Parkstar Apparel Ltd. (Extension)

Kunia, K.B. Bazar, Gazipur Sadar, Gazipur.

04th September 2023

1. Six Storied Extension Building (G+5)

Observations: Six storied Extension Building

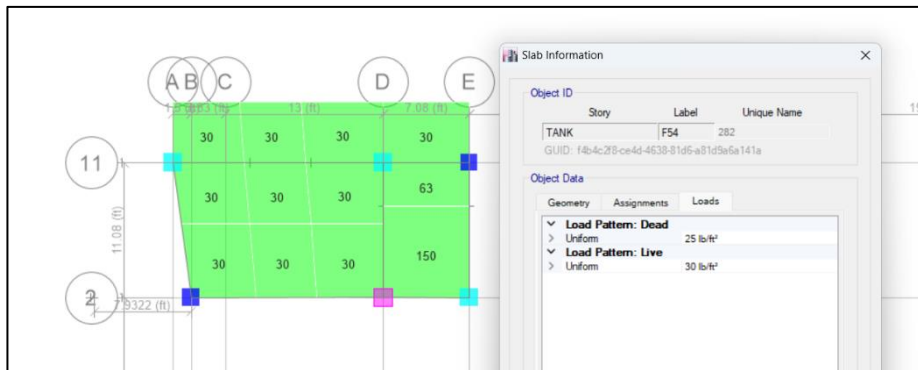
Overstress column in FEA model

Retrofitted steel beam

RC OHWT load not assigned in FEA

A Detail Engineering Assessment Report (DEA) was available on site which doesn't include any connection adequacy of retrofitted steel beams with RC columns. In FEA model RC OHWT load was not assigned, and some marginally overstressed columns were also observed. Building engineer is required to update the FEA model and design report by including the connection adequacy and other requirements as per BNBC.

Cracks on slab along the movement joints

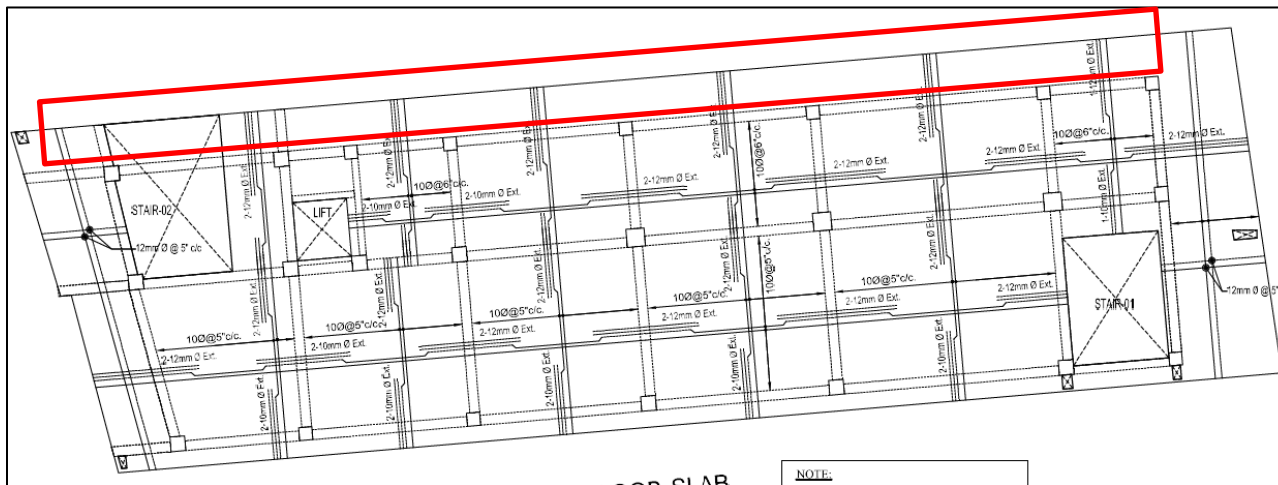
Cracks on slab was observed along the movement joint between Seven storied RC Building and Six storied Extension Building.

Building engineer is required to check the gap between two buildings and provide necessary calculation in the design report. Investigate the type of filling material along movement joint and suggest necessary remediation accordingly.
